Product/Process Change Notice (PCN)

File Number #: ConUSB_20150703_61400416021

Product Affected: 61400416021

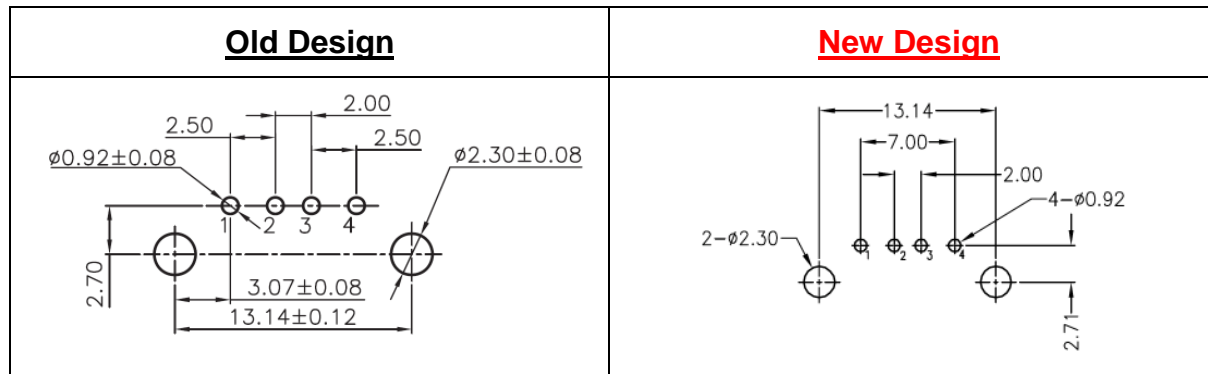
The dimension and the quantity of the tray is changed.

Old Packaging			New Packaging		
Tray dimension	Qty/Tray	Qty/Carton	Tray dimension	Qty/Tray	Qty/Carton
300x130x18mm	60 pcs	2640 pcs	270x220x16mm	100 pcs	4000 pcs

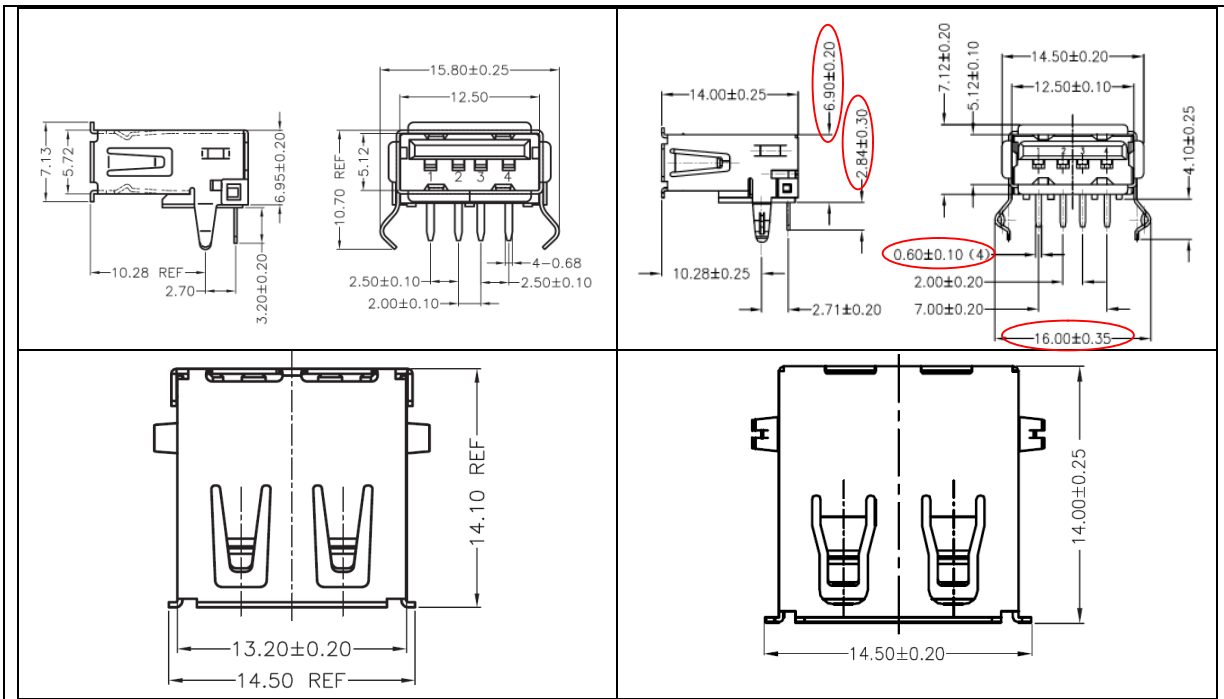
A fully automatized process will be implemented and CCD inspection controls will be added. The design changes are summarized below and marked in red:
